COUNTRYSIDE PROPERTIES

BELLE VUE GREYHOUND TRACK GORTON

SECTION 104 LAYOUT

Scale:	Size:	First Issue:	Drawn:	Checked:
1:500	A1	MAR 2019	CDW	ARA
Dwg No:	ELL-18039-B-CS-180			Rev:
				Q

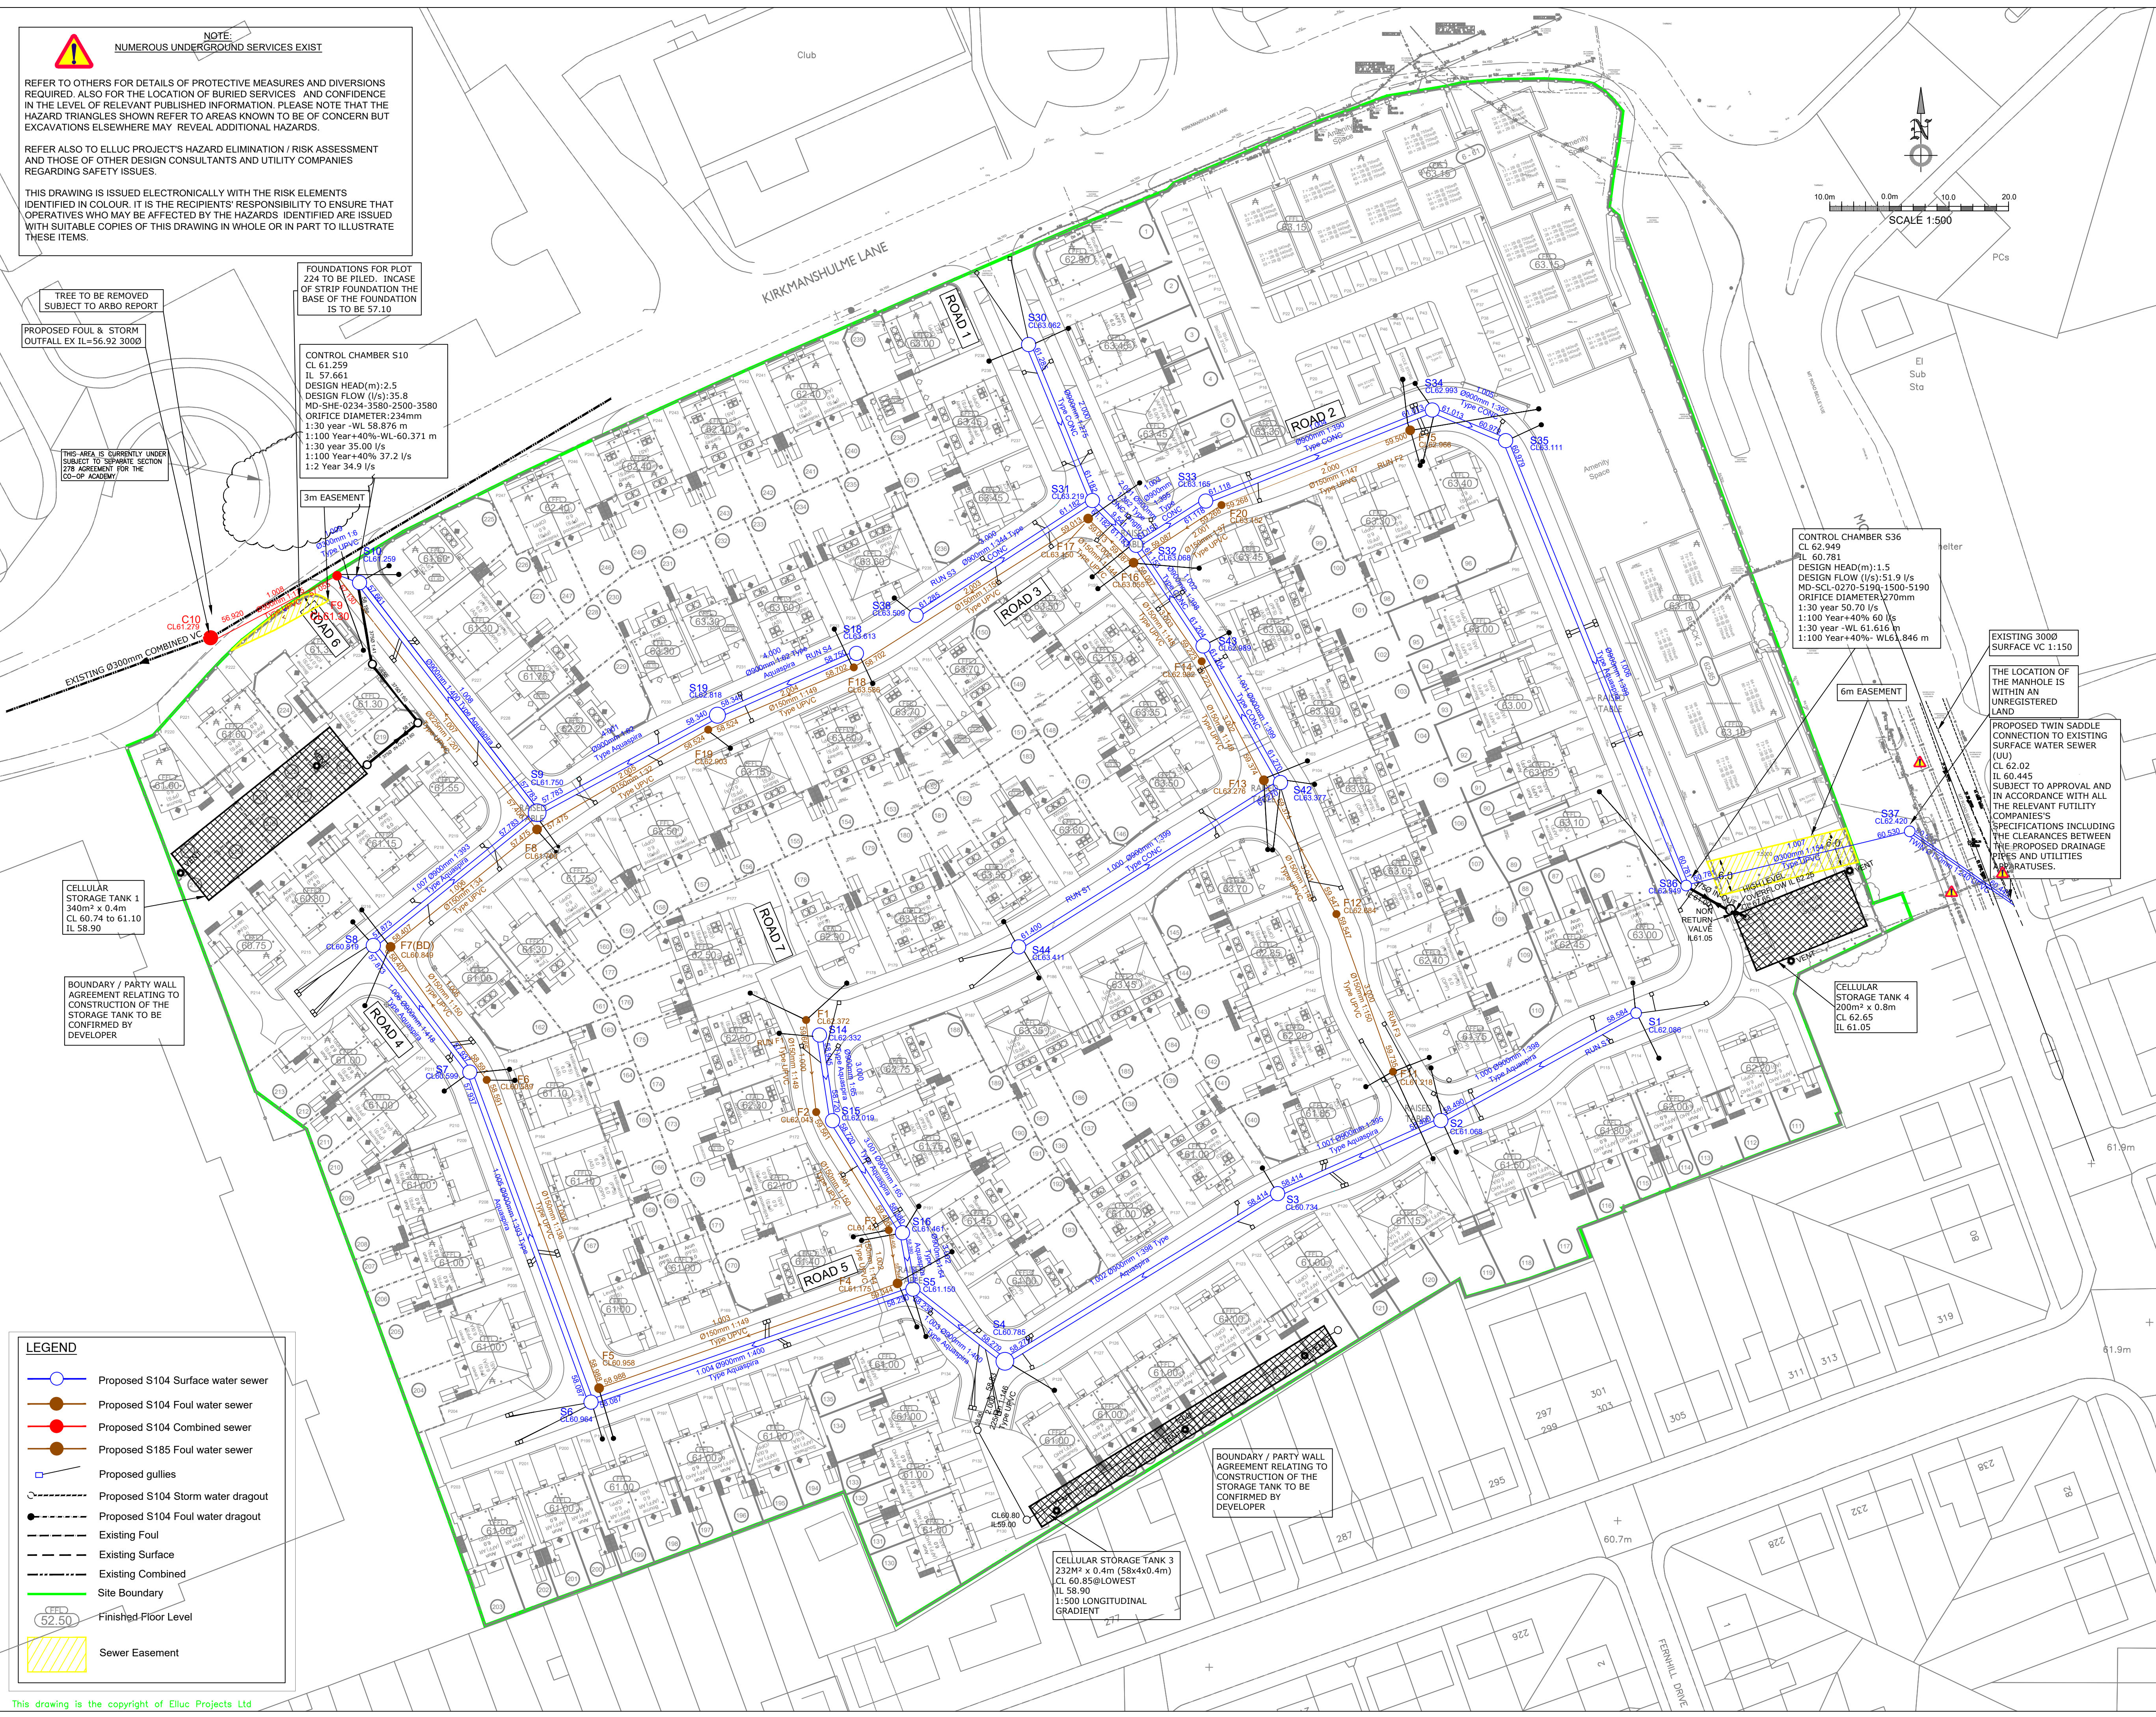
Q	PROPOSED TWIN SADDLE CONNECTION ADDED	21.04.2022	ARA
P	PROPOSED SADDLE CONNECTION NOTE CHANGED TO "PERFORMED Y JUNCTION"	12.01.2021	EK ARA
O	STORM WATER DRAINAGE FROM MH S36 HAS BEEN DIVERTED AND CHANGED TO A S4 SADDLE CONNECTION TO THE EXISTING STORM WATER SEWER AND EXISTING UTILITIES ADDED IN ACCORDANCE WITH CLIENT COMMENTS	07.01.2021	EK ARA
N	GULLER LOCATIONS HAVE BEEN UPDATED IN ACCORDANCE WITH S38 COMMENTS 14.07.2021	30.07.2021	ARA
M	MH F10 IS NOW CONNECTED TO MH F9 AND TANK 1 VENT PIPES REVISED	19.05.2021	ARA
L	STORAGE TANK 3 HAS BEEN REVISED AND BOUNDARY/PARTY WALL NOTE HAS BEEN ADDED	09.03.2021	EK ARA
K	POSITION OF HYDROBRAKE S10 CHANGED AND CO-ORDINATES AMENDED ACCORDINGLY TO SUIT UU S104 TECHNICAL APPRAISAL COMMENTS OF 24.08.2020	26.06.2020	CDW ARA
J	MANHOLE DETAILS FOR MH S4, S6, S8, F1, F4, F7 & F8 AMENDED TO SUIT UU S104 TECHNICAL APPRAISAL COMMENTS OF 05.08.2020	10.08.20	CDW ARA
I	MANHOLES AND LATERALS AMENDED TANK 1 & 3 LEVELS REVISED, MATERIAL FOR S2 TO S3, & S36 TO S37 TO SUIT UU S104 TECHNICAL APPRAISAL COMMENTS OF 23.06.20	22-7-2020	CDW ARA

H	EASEMENT AREA AMENDED BY MH F9 & S10	09.06.2020	CDW ARA
G	LATERALS ADDED TO MANHOLES S16 & S42 AND COLOURED BLACK. MH S1, S2, S3, S36 & S38 INVERT LEVELS, NT1 PN-1000, 1001, 1002 & NT2 PN-1005, 1006, 1007 GRADIENTS AMENDED TO SUIT S104 TECHNICAL APPRAISAL COMMENTS ON 26.02.20	16.03.2020	RL ARA
F	PIPE RUN FROM MH S4 TO CELLULAR STORAGE TANK 3 CHANGED FROM COLOUR BLUE TO BLACK. MH F1, F4, F7, F8, F10, S1 & S18 COORDINATES, FW PIPE 1:000, 1:005, 2:004 & SW 3:001 GRADIENTS AND MH F16 CL AMENDED TO SUIT S104 TECHNICAL APPRAISAL COMMENTS ON 31.01.20	24.02.2020	CDW ARA
E	DH F1, F4, F7, F8, F10, S1 & S18 COORDINATES, FW PIPE 1:000, 1:005, 2:004 & SW 3:001 GRADIENTS AND MH F16 CL AMENDED TO SUIT S104 TECHNICAL APPRAISAL COMMENTS ON 31.01.20	11.02.20	RL ARA
D	DETAILS AMENDED TO SUIT S104 COMMENTS-2	09.01.2020	RL ARA
C	TANK 2 OMITTED, TANK 1 UPSIZED & RE-LOCATED TO CLIENTS COMMENTS	02.09.2019	CDW ARA
B	REVISED TO NEW LAYOUT AND SITE LEVELS	27.06.2019	CDW ARA

A	REVISED TO SEC 104 COMMENTS	10.05.2019	RL ARA
Rev.	Description:	Date:	By: Chkd:
